Access Compliance Report

(Curb Ramps)

Intersection ID: 29131	Main Street: ALDERPOINT_LN	Cross Street: ANGWIN_PL	Location: SE
ADA ID: 00BBF01AE58D	Ramp Type: BlendTrans1	Initial Pass/Fail: Pass	Overall Compliance: No
Severity Score: 25.25			
Codes/Mitigation Info/Possible Solution		Field Measurements/Component Compliance

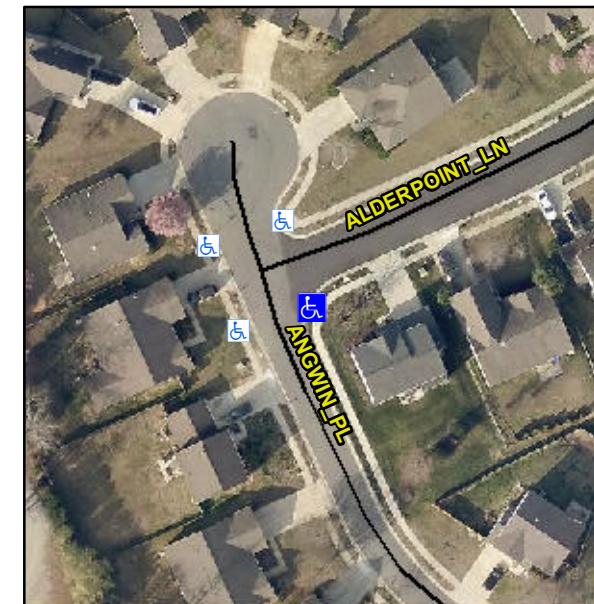
R304.5.3, R305, R302.7.2

Compliance	Description	Data	Compliance	Description	Data
N/A	Ramp Length (in)	46.5	Yes	BlendTrans Slope (%)	4.4
Yes	Ramp Width (in)	119.0	No	BlendTrans XSlope (%)	3.3
N/A	Flare Type LT	Sloped	N/A	Flare Type RT	Sloped
N/A	Flare Slope LT (%)	0.3	N/A	Flare Slope RT (%)	5.4
N/A	Flare Traversable LT?	No	N/A	Flare Traversable RT?	No
Yes	Landing Length (in)	48.0	No	DWS Provided?	No
Yes	Landing Width (in)	119.0	N/A	DWS Contrast?	No
Yes	Landing Slope (%)	0.7	N/A	DWS Length (in)	N/A
No	Landing X Slope (%)	4.3	N/A	DWS Full Width?	No
N/A	Landing Curb? (Y/N)	No	N/A	DWS Offset (in)	N/A
N/A	Shared Landing?	No			
Yes	Gutter Ponding?	No	Yes	Gutter Slope (%)	3.2
No	Gutter Lip Ht (in)	1.0	No	Gutter X Slope (%)	4.7
N/A	Painted X Walk1?	No	N/A	Painted X Walk2?	No
	X Walk 1 Direction	To N		X Walk 2 Direction	To SW
	X Walk 1 Width (in)	N/A		X Walk 2 Width (in)	N/A
	X Walk 1 Slope (%)	0.6		X Walk 2 Slope (%)	2.4
	X Walk 1 X Slope (%)	4.7		X Walk 2 X Slope (%)	0.6

Remove & Replace Curb Ramp With Two New Directional Ramps or Equivalent. Remove & Replace Gutter.
